Re: Zircaloy Clad
 Conversion
 ISAP Topic 2.17

Haddam Neck Plant
 Additional Information
Small-Break Loss of Coolant Accident Analysis--
Zircaloy Clad Fuel

Attachment
Haddam Neck Plant
Additional Information
Zircaloy Clad Fuel Small Break LOCA ECCS Analyses

FIGURE 1
 RUPTURE TEMPS VS. CLAD PSID
 FOR NULAPS AND NUREC-0630

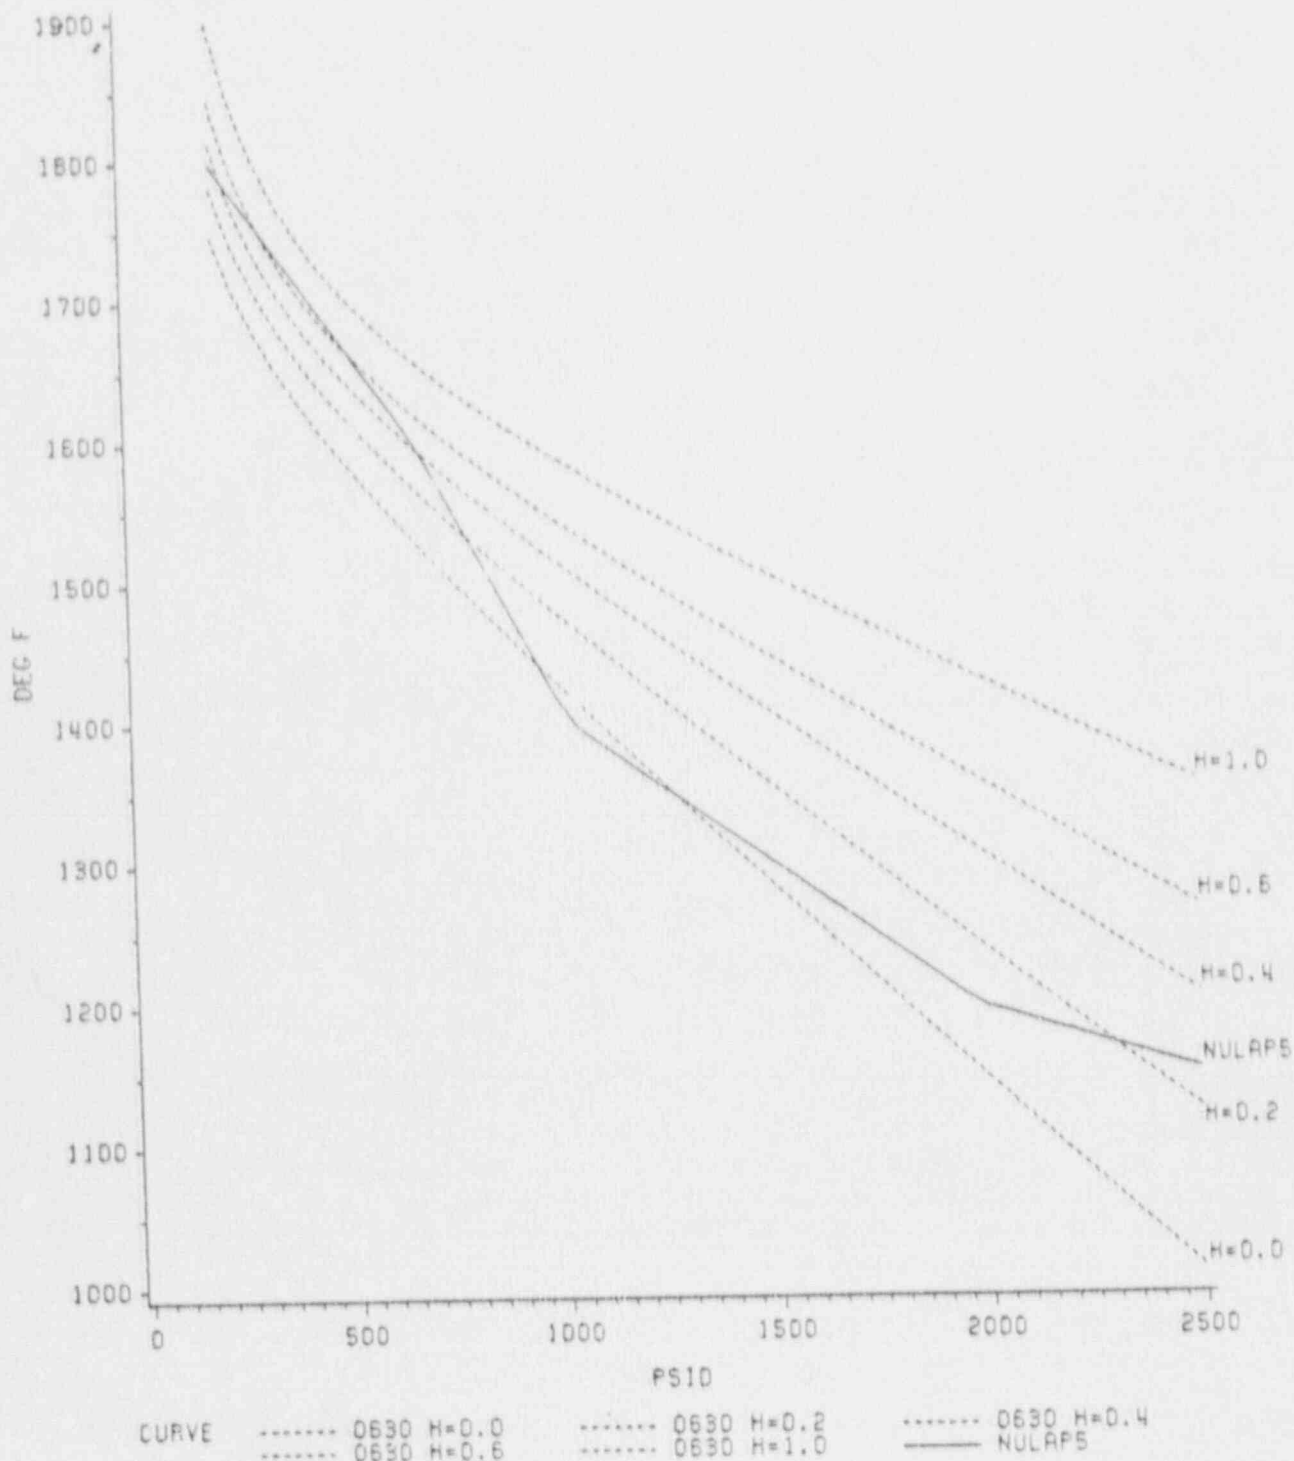
Northeast Utilities' response to question 1 compared rupture temperatures based on NUREG-0630 and NULAP5 calculated clad temperatures. This comparison showed that no rupture was calculated. However, the figures provided do not compare the NULAP5 and NUREG-0630 rupture temperatures to show which is more conservative. Provide this comparison. Also the statement is made that the NULAP5 models are more conservative than the NUREG-0630 models because the NULAP5 models can account for prerupture cladding swell while the NUREG-0630 models do not. However, given the way the NULAP5 models are formulated in the code, the input needed to describe zircaloy clad deformation are tables of percent elongation and ultimate tensile strength versus temperature. This data is available in NUREG-0630 (see Figures 3, 6 and 7 and Appendix B) and could be used as input to the NULAP5 models just as the data from the report by Lowe was input to the NULAP5 models. Therefore, compare NULAP5 results where NUREG-0630 data and data from the Lowe report are used as code input to justify the conservatism of the NULAP5 models using the Lowe data.

Figure 1 shows a comparison of NULAP5 and NUREG-0630 rupture temperatures. The rupture temperatures are given as a function of pressure difference (internal minus external pin pressure) over the applicable range for LOCAs. Since 0630 rupture temperature is a function of "H" -- the ratio of heating rate (deg-C/sec) to 28 deg-C/sec -- and hoop stress, five 0630 curves were generated to show this comparison over the possible range of H from 0.0 to 1.0. The figure shows that the NULAP5 rupture temperature calculation is conservative except for lowest pressure differentials.
